Information Requests for Effects Analysis

Figure 16-13. American River at Watt Avenue, April

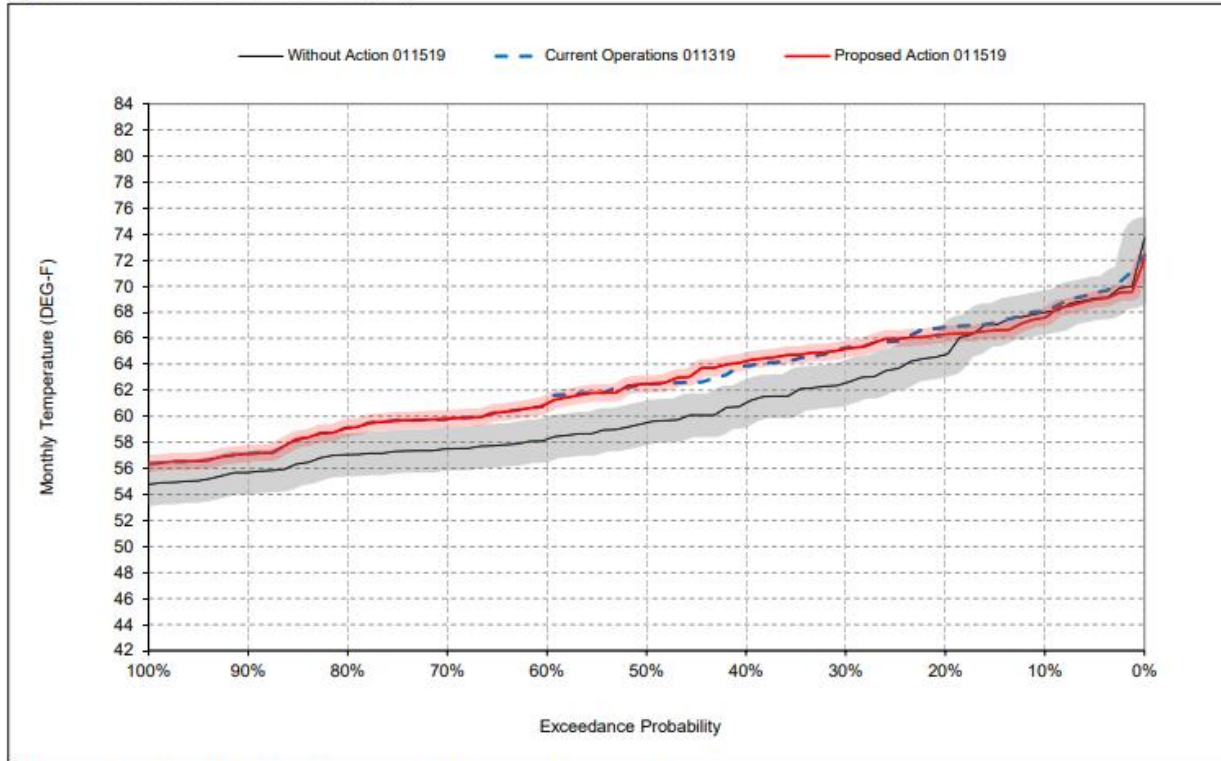
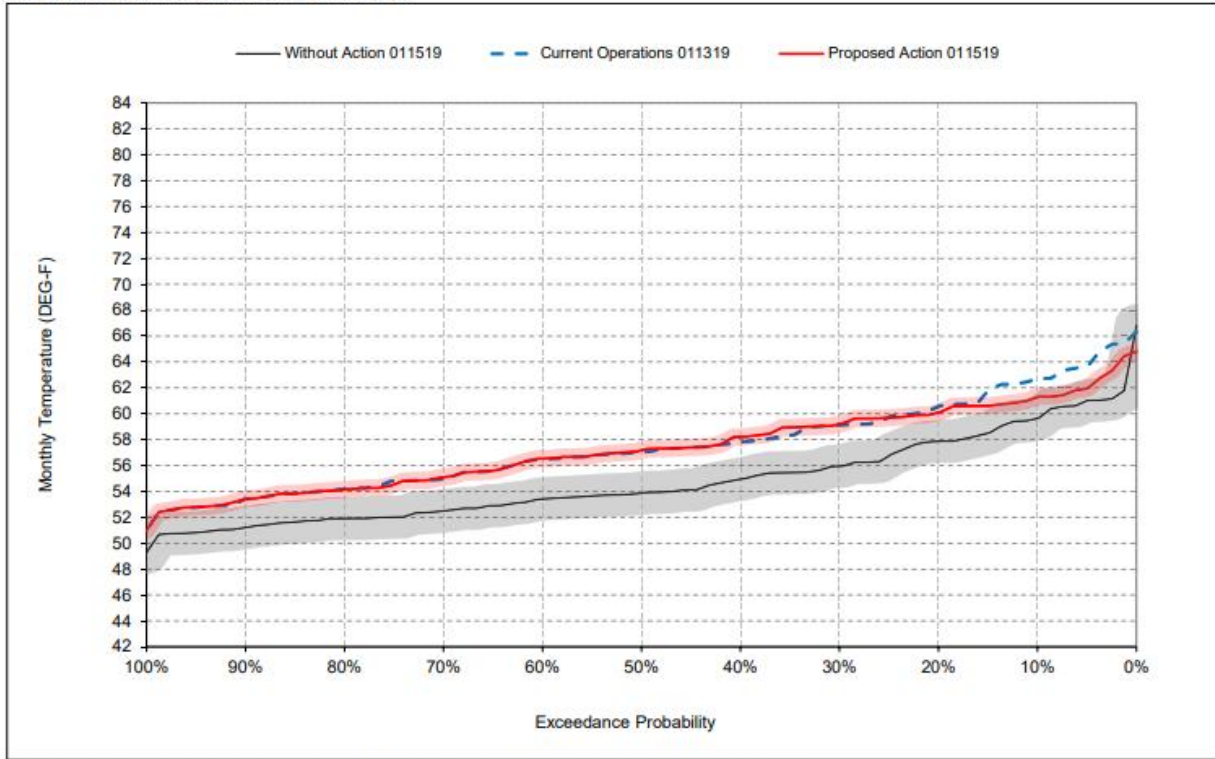
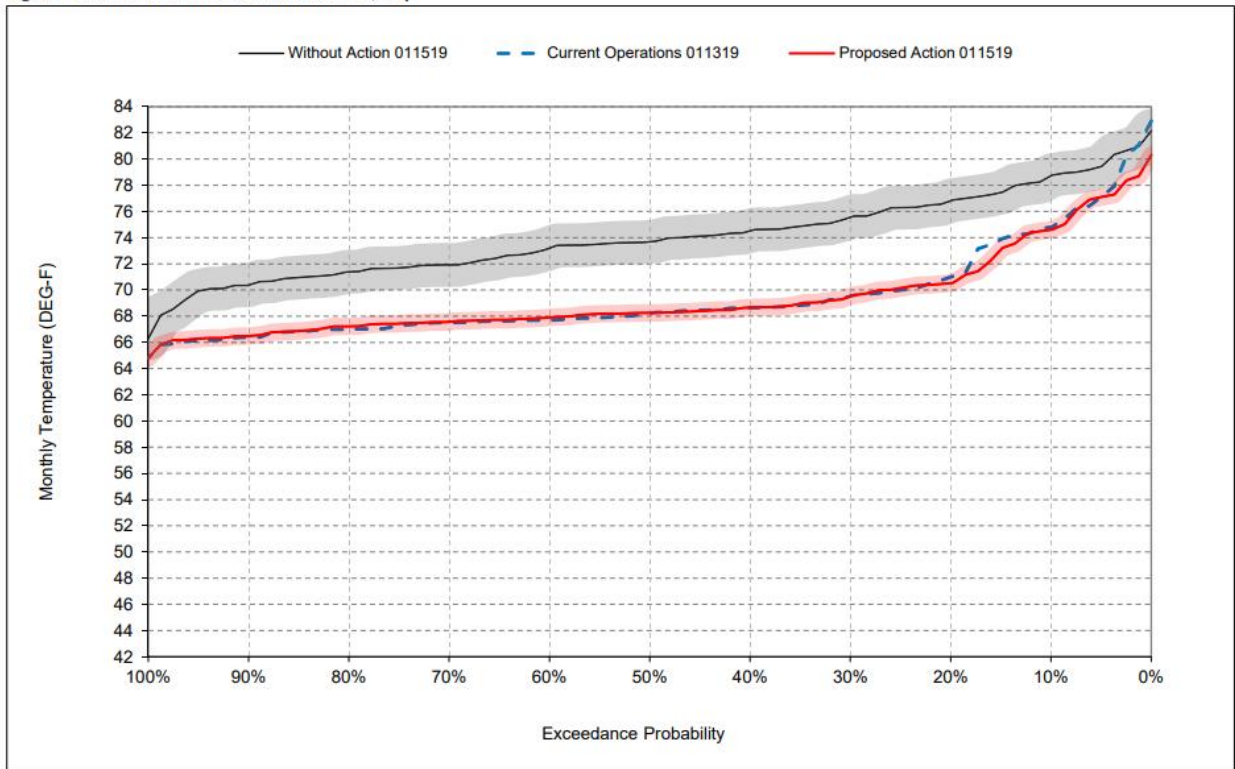
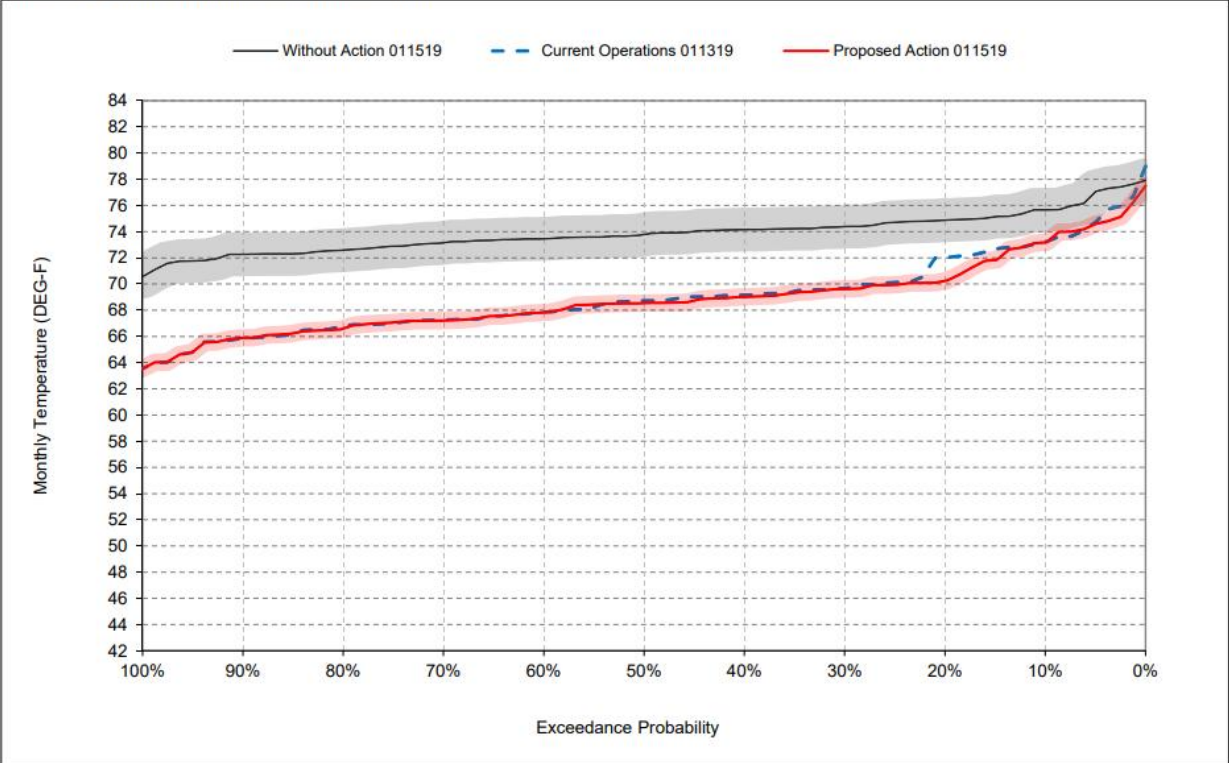
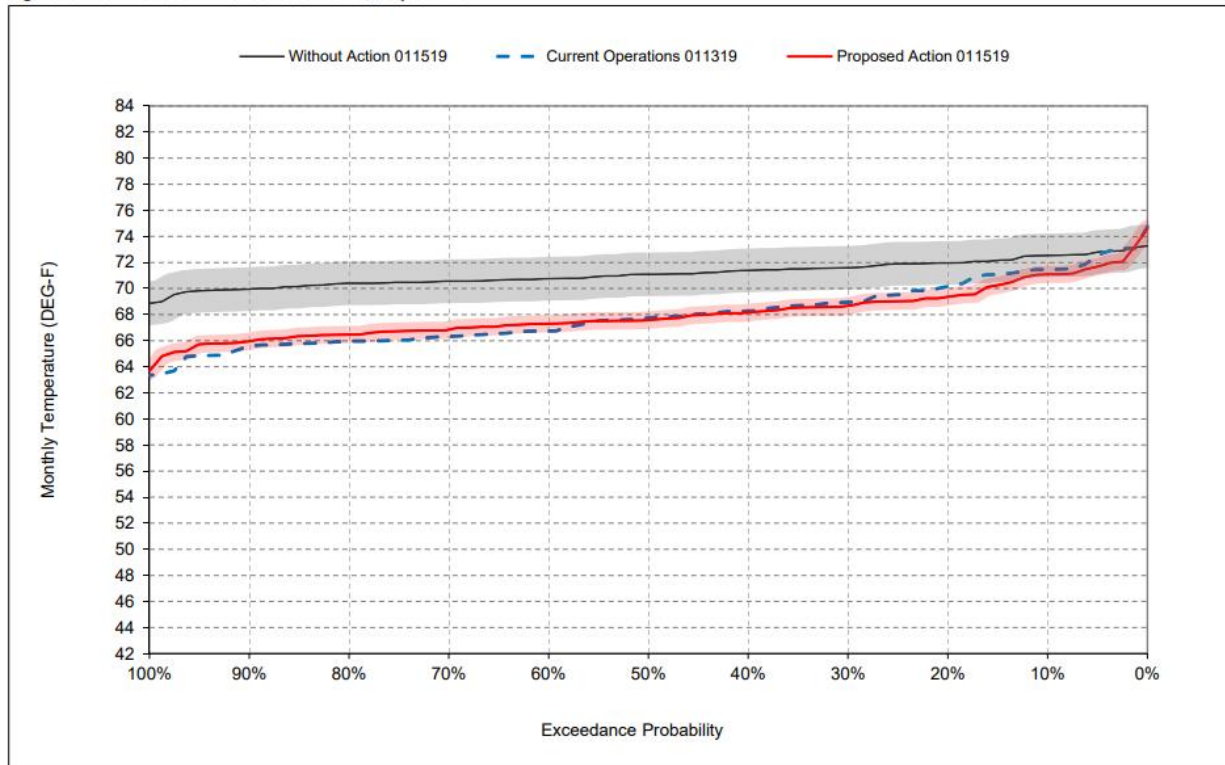
Please provide the following figures from the BA Appendix D with the Without Action scenario removed and the y-axis re-scaled to focus on the resultant range of temperatures in each figure (we don't need the scale up to 84 F when he warmest temperature is less than 70 F)
